PUBLIC COMMENT FOR ITEM 7: ITEMS NOT APPEARING ON THE AGENDA

PUBLIC COMMENT FOR ITEM 9A: SUSTAINABLE YIELD VOTE

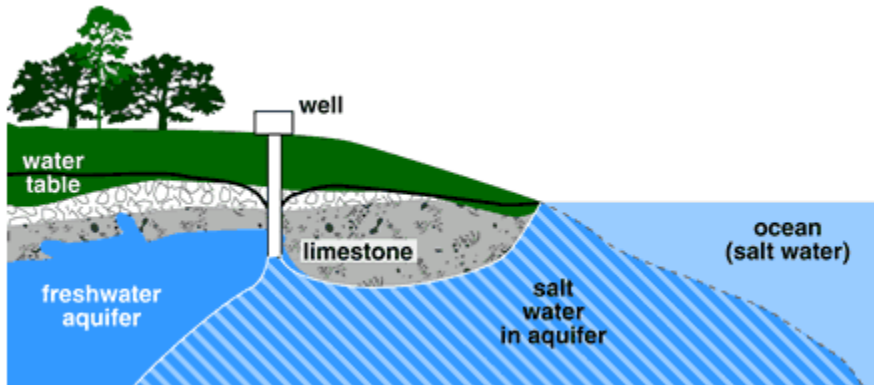
My understanding of the Annual Report is that the groundwater model is updated yearly to reflect annual recharge and withdrawals and is ran to a new steady-state solution. In that case, published figures should include the following changes from one year to the next: 1) change in water levels for each model layer, 2) change in the location of the salt-water interface (or 250 mg/L chloride) for each

model layer, 3) change in withdrawals from each model cell for each layer. This would provide a much broader understanding of the system than metrics collected and simulated at four wells.

Figure 23
Chloride and Water Level Metric
Los Osos Groundwater Basin
2023 Annual Report

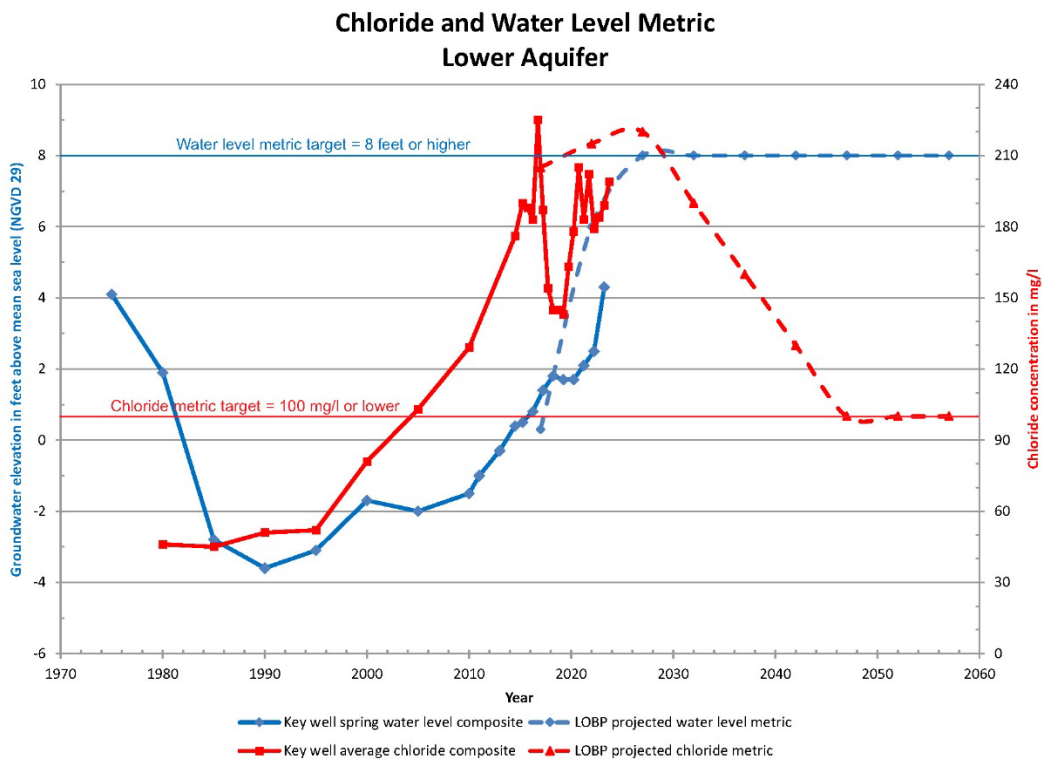
The chloride metric has not decreased, even with withdrawals being 69 percent of estimated sustainable yield, so it appears the estimated sustainable yield is too high. It is true that water levels increased, but it was a good water year with less pumping. The projected lines on Figure 23 of the Draft 2023 Annual Report need better explanation. They cannot be model output, because steady-state models cannot simulate changes through time. It is possible that a steady-state model is being used for current conditions, and then a different steady-state model (same aquifers, different well locations, withdrawals, and recharge) is being used for the flat projected lines of water levels and chloride concentrations. The time to achieve those levels cannot be determined with any steady-state model.

Whatever the method used to draw the projected lines, it appears to be incorrect. The actual water level metric has not risen nearly as fast as the projected water level metric, and most of the rise was because of the of the high precipitation and low withdrawals in 2023.

The current estimate of sustainable yield appears to be too high and a new estimate should be developed. The new estimate needs to include reductions in recharge that will occur if more water-conservation efforts are undertaken.

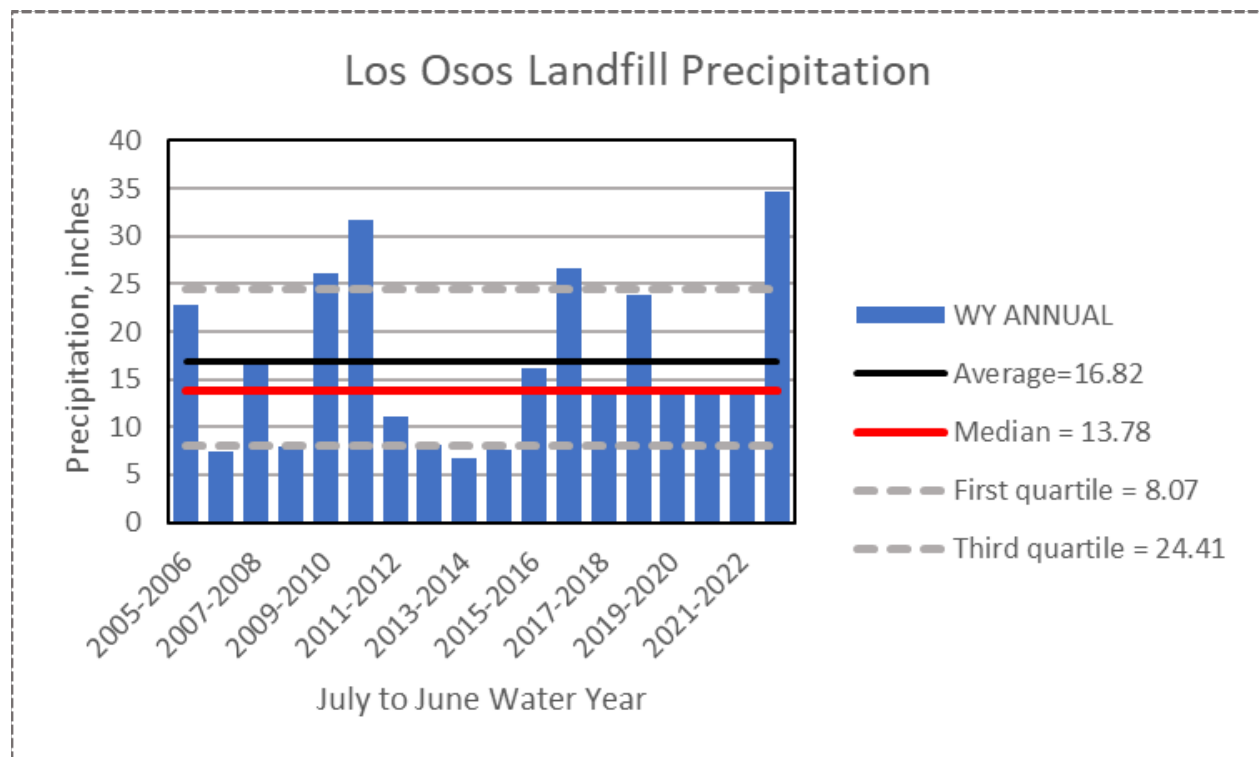
Using 17.3 inches/yr of precipitation to determine water budgets and model input may be too high. Page 42 of the 2023 Draft Annual Report states the Los Osos Landfill precipitation gage has “a lower average due to short period of record that includes seven years of below normal rainfall.” Through water year 2023 (July 2022 to June 2023), the gage had 18 years of record. If seven years were below normal, then 11 years were above normal. The report does not clarify what data were used to determine “normal”.

Most hydrologic studies use median rainfall, not average, because median is less influenced by extreme events. For the period of record, the median rainfall at the Los Osos Landfill was 3 inches less than the average rainfall. The median being substantially lower than the average is true across all of San Luis Obispo County as shown in a hydrologic report prepared by SLO County 2002 Hydrologic Report (<https://www.slocounty.ca.gov/departments/public-works/forms-documents/water-resources/groundwater-reports>). It is important to use water year for hydrologic studies because often the period December through February or so is the wettest period. Using calendar year divides those months, which does not make hydrologic sense.
